Staff Report & Recommendation

Design Review Board

SUBJECT: DRB17-0148

160 South Hibiscus Drive – Single Family Residence

Portion of the 1923 Hibiscus Island Subdivision (subject property Lot 24)

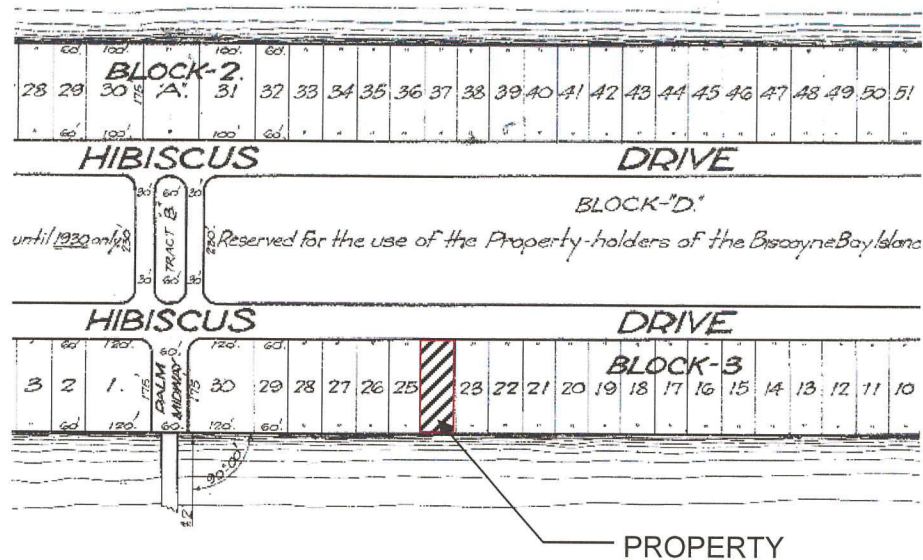
Variances #2, #3 and #4 are related to the same zoning regulation. As the subject site is 60.1' in width, as noted in the survey provided, both side setbacks are required to be 10'-0". Lots 60'-0" in width have a minimum setback requirement of 7'-6". The block was originally platted with the majority of the lots not exceeding 60'-0" in width. Today with more accurate and precise measuring instruments than when the property was originally platted, the lot width of the subject site is shown to measure 60.1', representing about 2" of a difference. The majority of the properties within the block and the adjacent properties measure 60'-0" in width. Staff finds that the subject property is a unique lot within the block, regarding its width, and the required side setbacks would impose an undue hardship on the applicant that does not apply to most of the properties within the same block. The proposed setback of 7'-6" on both sides is consistent with the required setback for the other surrounding properties. Therefore, the applicant's request would not create a negative impact to the neighboring properties.

The subject property is an interior lot on a block within the Amended Plat of Sunset Lake Subdivision, which was historically platted on June 12, 1923, as noted in the graphic below. Without the granting of this variance, the construction of the building on the lot would be more restrictive than its immediate neighbors and the site could not be developed as other lots in the same district and same platted subdivision.

Staff is supportive of these variances (#2 and #3 and #4) since the current site configurations summarize the Practical Difficulty and Hardship Criteria.
